**SUBJECT: NEW VEHICLE DEMONSTRATION / DELIVERY HOLD  
 Customer Satisfaction Program 21B03 - *Supplement #4***  
 Certain 2020 Model Year Super Duty F250-F600 Vehicles Equipped with a 10R140  
 Transmission - Number One Planetary and Ring Gear Assembly

**REF: NEW VEHICLE DEMONSTRATION / DELIVERY HOLD  
 Customer Satisfaction Program 21B03 - *Supplement #3***  
 Dated: May 5, 2021

**New! REASON FOR THIS SUPPLEMENT**

FIGURE 33

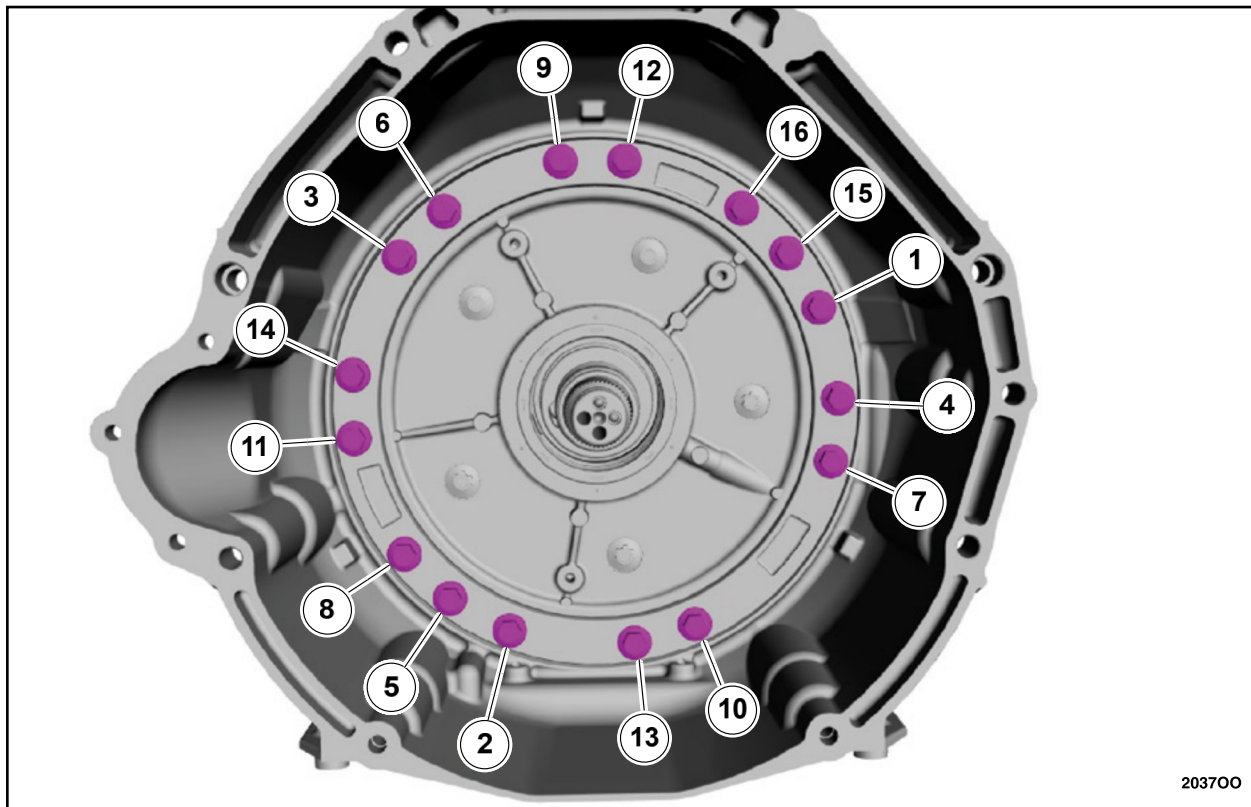
**NEW!** 37. Tighten the bolts in the sequence shown. See Figure 33.

- Torque: *26 lb.ft (35 Nm)*.
